Joint Meeting of the RID Committee of Experts and the
Working Party on the Transport of Dangerous Goods

Tanks: Interpretation of construction requirements applicable to the opening ends of Vacuum-Operated Waste Tanks (VOWTs)

Transmitted by the Government of the United Kingdom

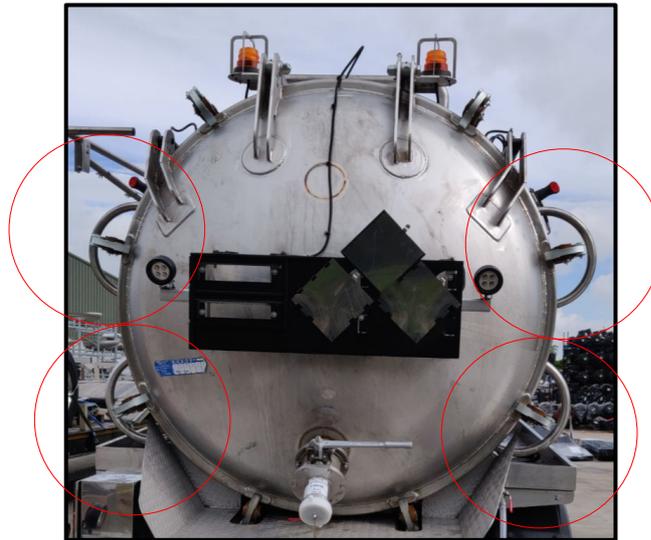
3. The following image provides an indication of the protection that can be provided by additional measures to protect hydraulic over centre type clamps in order to prevent the door from being forced open during a roll-over incident.

4. In our opinion, providing this additional protection to hydraulic over centre type clamps results in the requirements of ADR 6.10.3.5 (e) being fulfilled. However, as an alternative to this additional protection, it has been suggested that it would be acceptable for a sufficient number of unprotected over centre type clamps to be used to clamp the rear door in the closed position. The number of clamps would need to be such that, if those on either the left, right and/or top sides of the rear door were damaged in a roll-over, it would be possible for the remaining clamps on the undamaged sides, provided they are so designed, to prevent the rear door from being forced open.
